Technical Bulletin

X-crypt External Dongle Support Modification.

Identify the Soldering point (See image below)

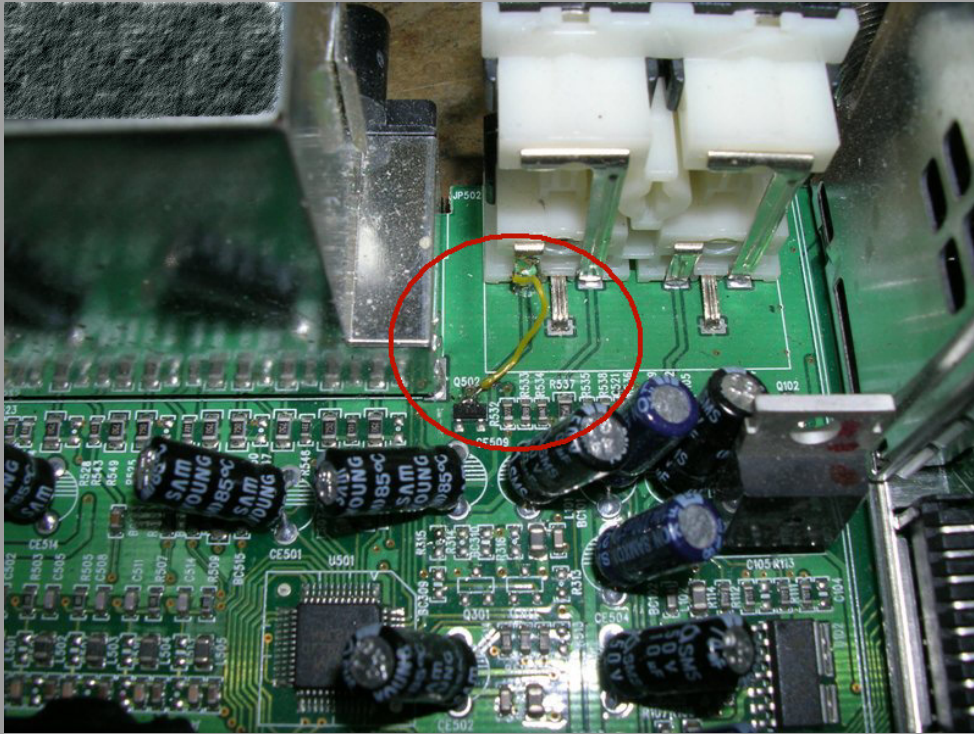
This technical bulletin is issued to inform you about how to install new generation Xcrypt Dongle without an external DC supply in AstroVox VSR-260 FTA Plus receiver... This Technical Bulletin provides complete hardware modification procedures that allows user to make use of a Dummy RCA Connector to provide DC to Xcrypt Module.

Connect a Small Piece of jumper in between to marked points.

Connect Xcrypt Module to RCA Connector and check the LED
